Figure 3. Approved Cable Routes

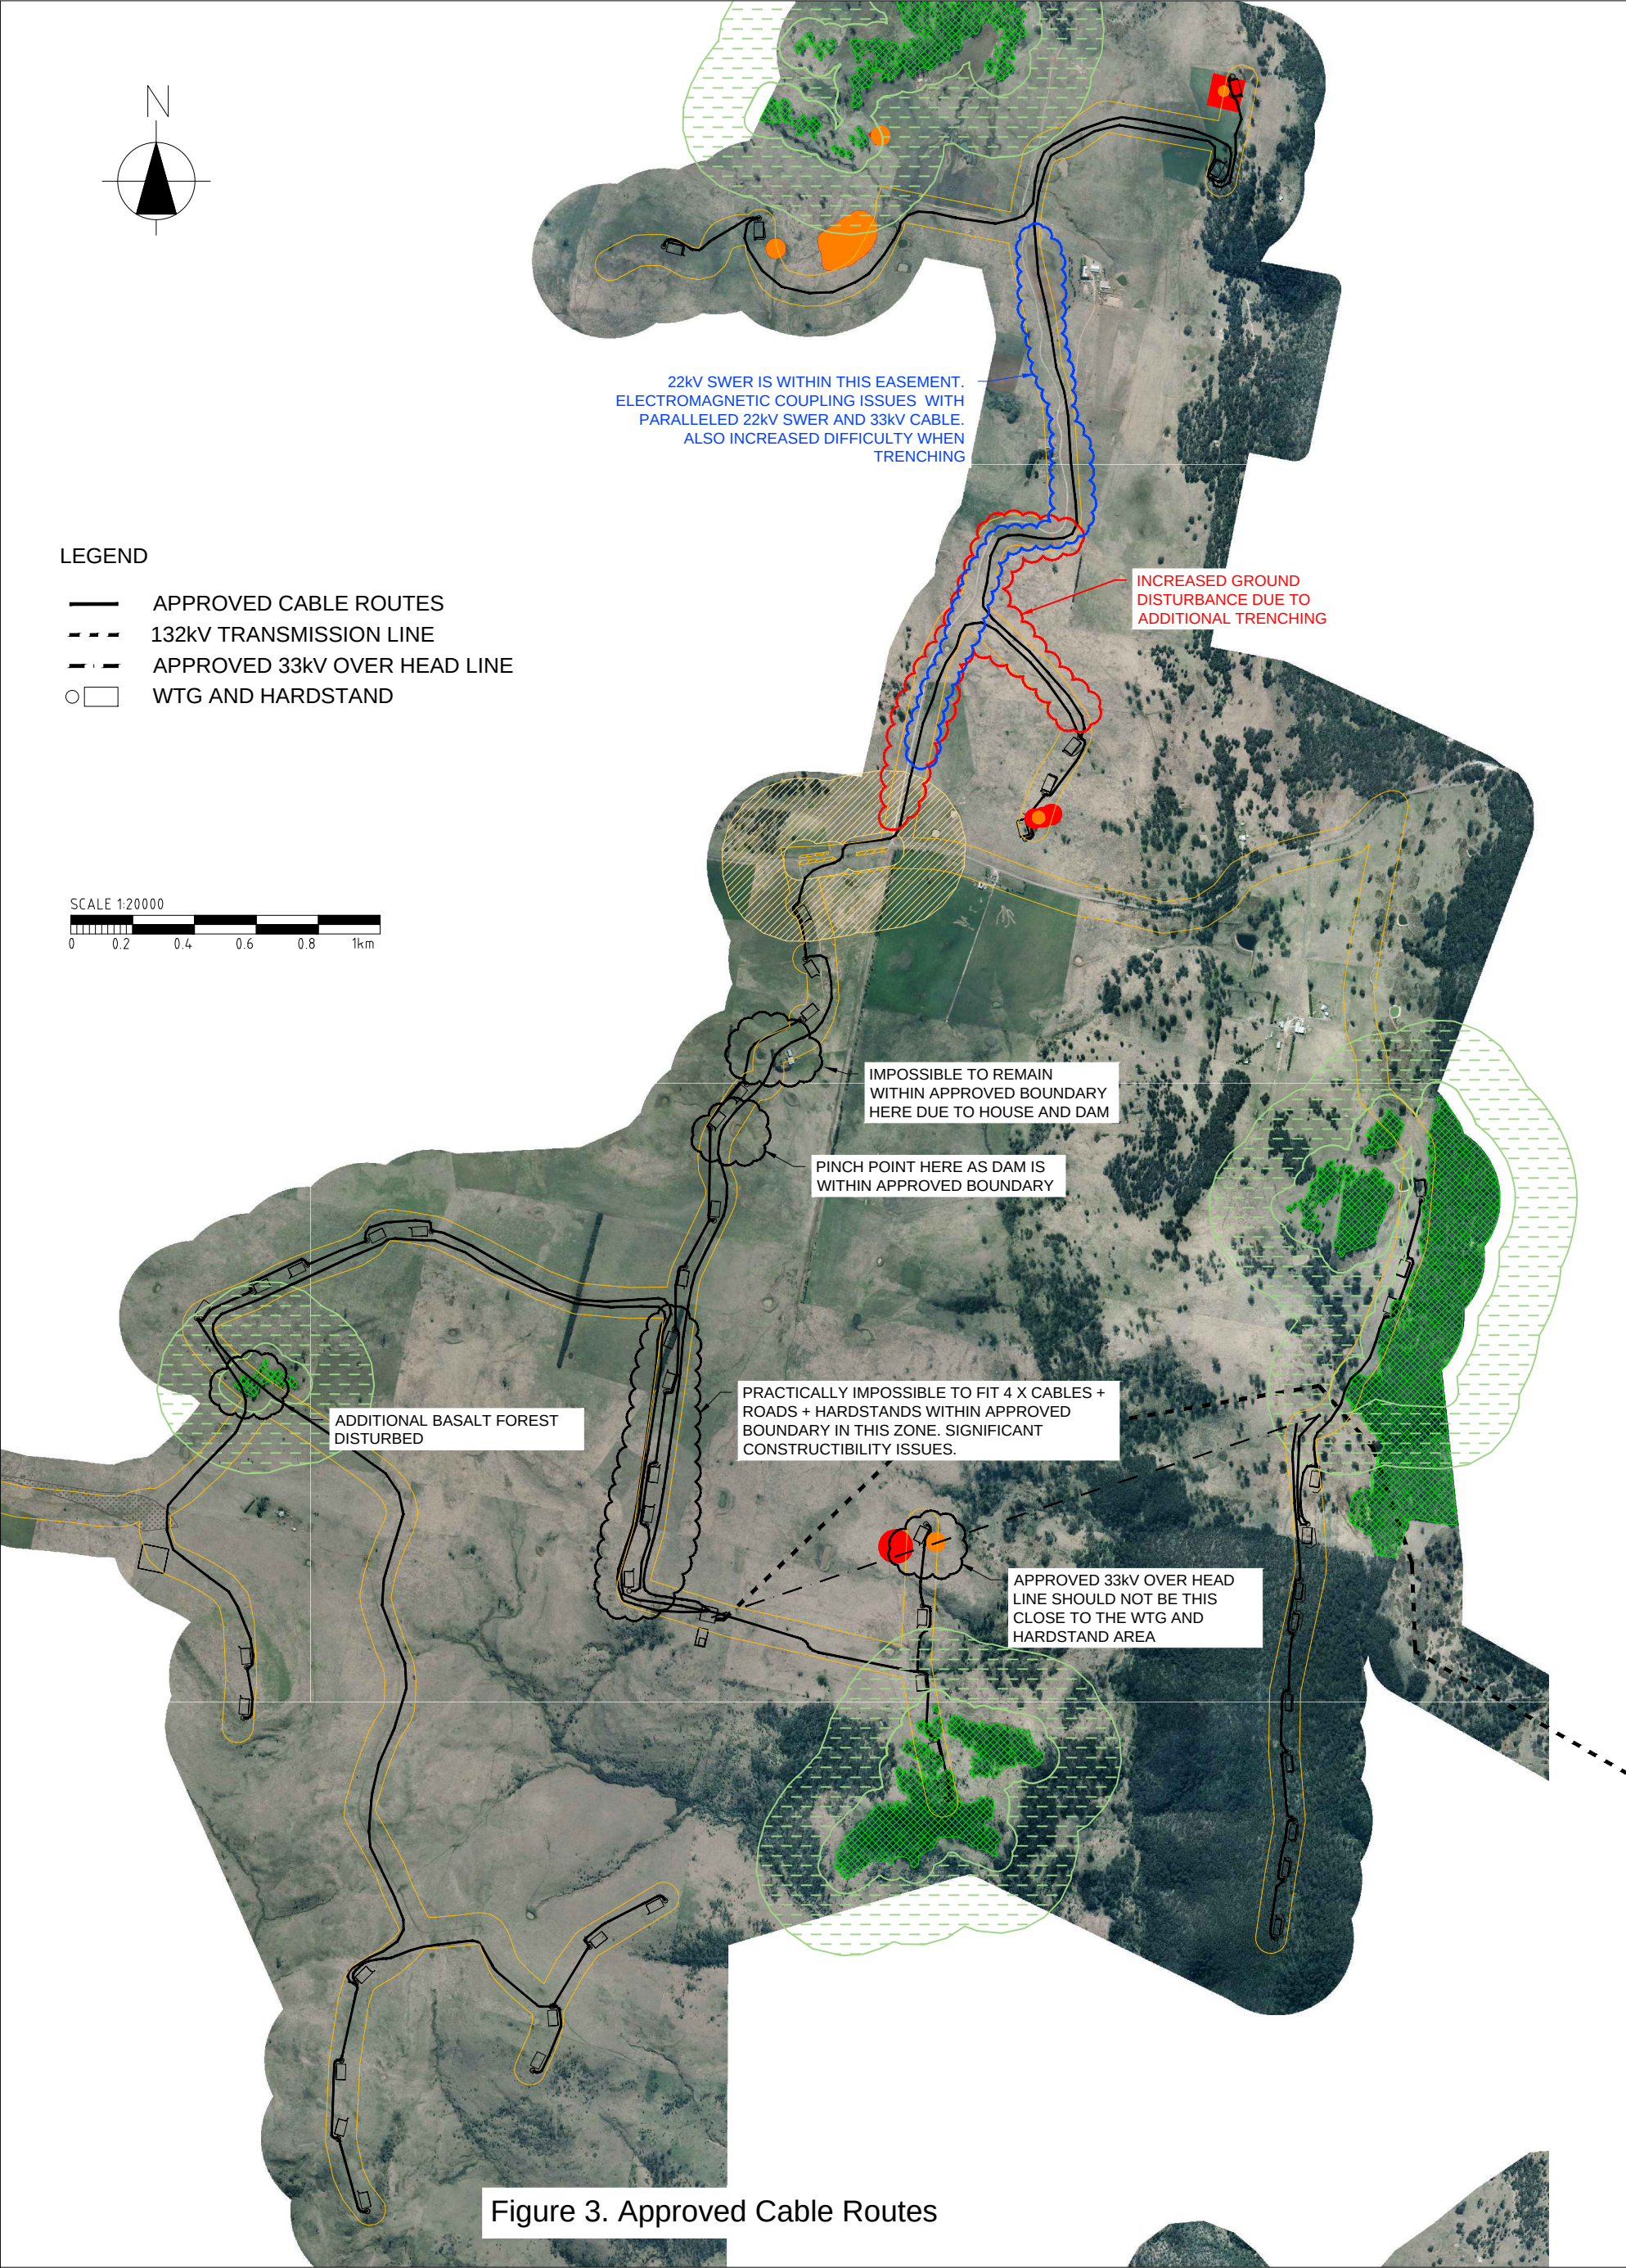
The current consent conditions for the Project specify underground cabling to connect the wind turbines to the substation with the exception of two locations where overhead power lines will be used. Section 2.5.7 of the EIS states that the cables are to be laid in a trench approximately 0.5m wide by 1m deep adjacent to the access tracks. In instances where double circuits are required, trenches would be slightly wider or undertaken on both sides of the access track. The approved Project will result in disturbance of 7.84 hectares associated with underground cabling. The specific issues related to the approved cable routes are shown in Figure 3.

Figure 4. Approved 33kV Overhead Transmission Line and Proposed Modification

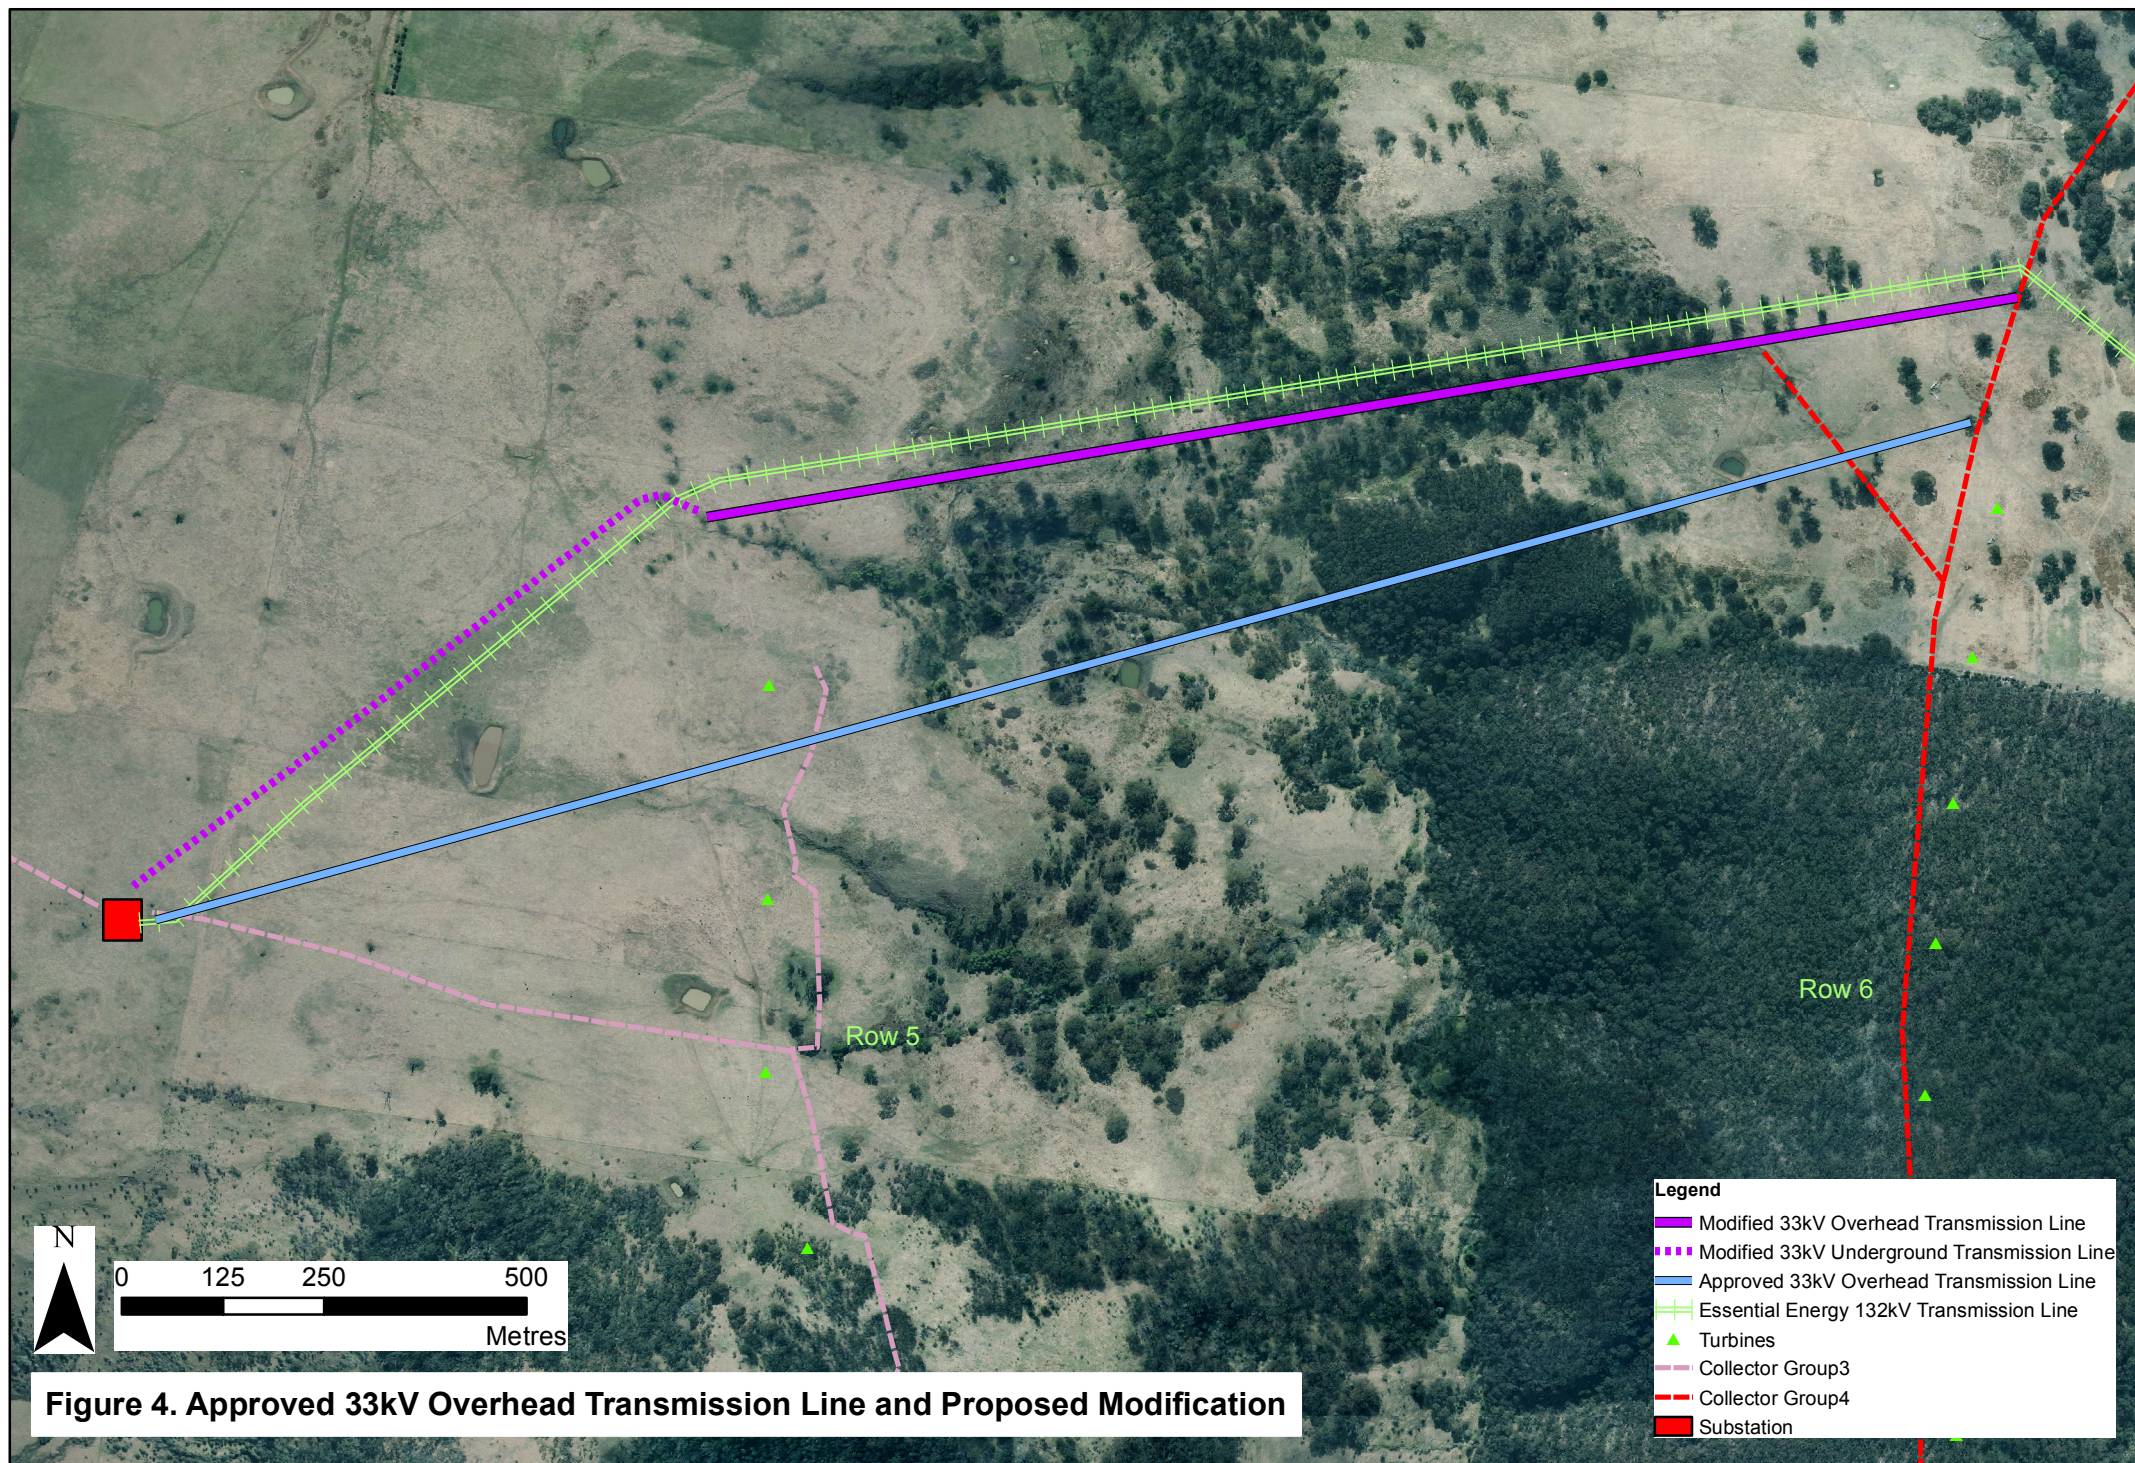
It is therefore proposed to modify the alignment of the overhead 33kV transmission line to eliminate these engineering constraints. The current approved alignment is a straight line from turbine rows 6 and 7 to the substation resulting in the transmission running between turbines 18 and 19. The proposed new alignment for the 33kV transmission line to connect turbine rows 6 and 7 to the

substation is immediately adjacent to the approved, but not yet built, Essential Energy 132kV transmission line alignment as shown in Figure 4. This proposed alignment is to the north of turbines 18 and 19. The two transmission lines would be adjacent to each other with the 33kV line on the southern side of the 132 kV line. A 40m wide easement would be established for the 33kV line, side by side with the 132kV easement.

The proposed modified alignment would only require 18.5m high poles with an associated reduction in visual impact. Furthermore, as the topography is suitable, an approximately 800m section of the proposed 33kV line that connects into the substation could be placed underground, similar to the majority of turbine connections within the Project, which would further reduce the visual impact. The section of overhead line would be carried by single poles and the route would include an access track for construction and maintenance to the final pole on both the eastern and western sides of the gully. The steepest part of the gully would be spanned (Figure 6) with no access track required across the drainage line.

Figure 5. Approved Access Tracks and Proposed Modifications

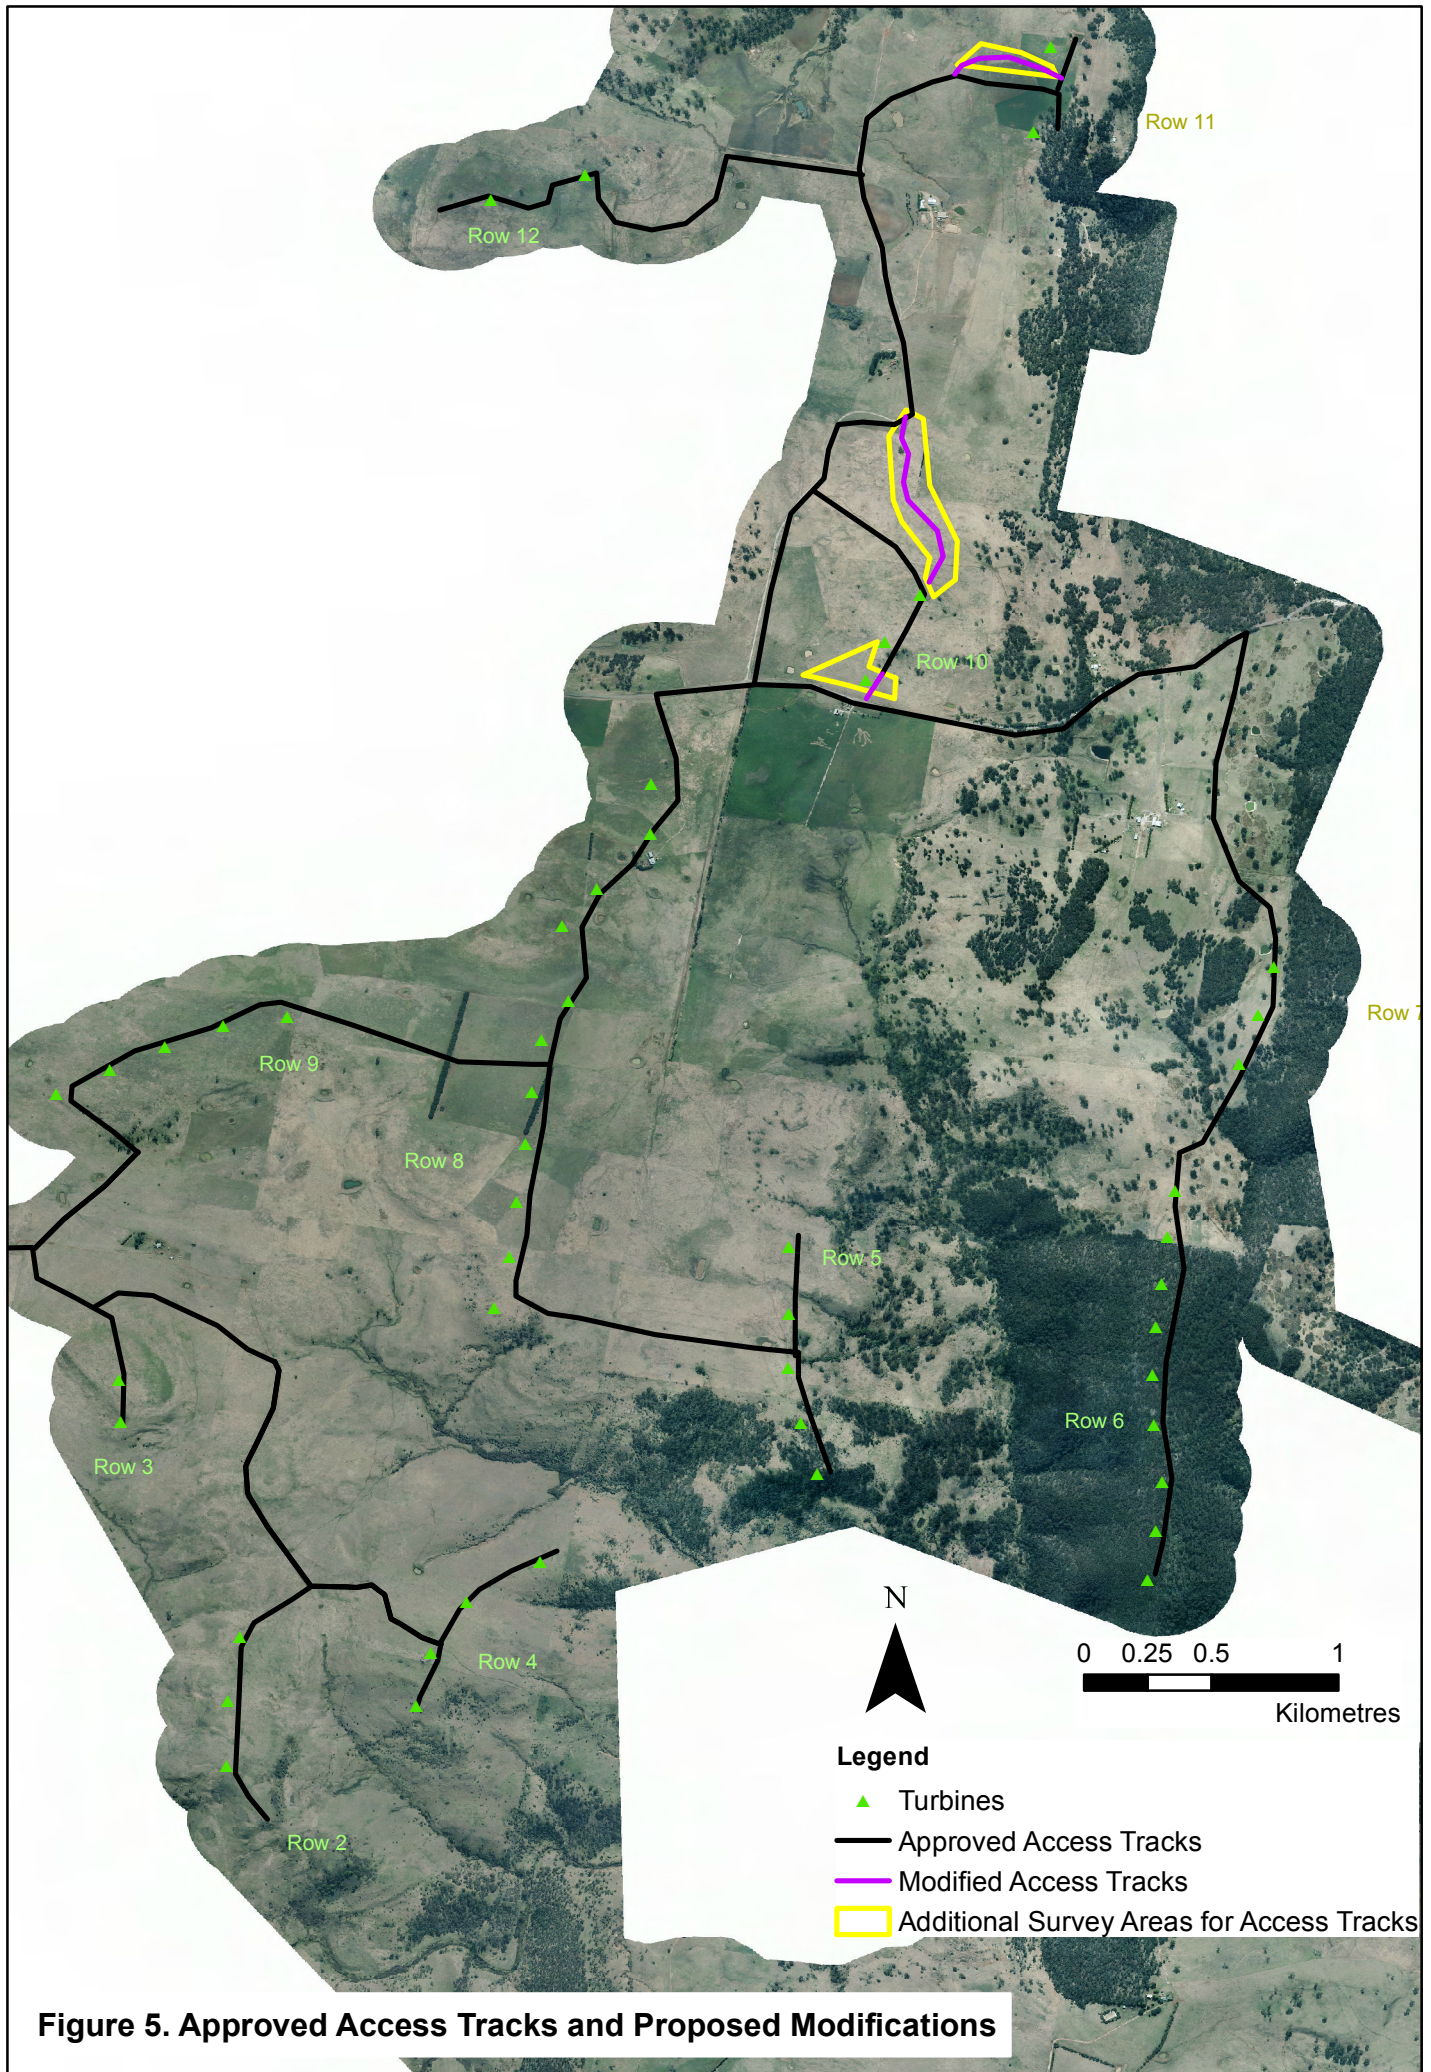
The EIS (Figure 2.4) identifies both new access tracks and existing tracks to be upgraded. Following further detailed design for the Project, two modifications to the alignment of access tracks are proposed (Figure 5). The location and details of the two modifications proposed are as follows:

- Access to turbine row 10 would be modified by changing the alignment of the new track from Turbine 51 to Alders and Crees Road and establishing an additional small section of new track to connect Turbine 49 to Bannaby Road. This would allow vehicles to effectively enter and exit this turbine group in the one direction eliminating the need for vehicles to perform a turn around manoeuvre on a hilltop and side slope; and
- Minor alignment change to new access track off Alders and Crees Road to turbine row 11. The alignment would be changed over a length of approximately 200 m to avoid the recently approved met mast site at this location.
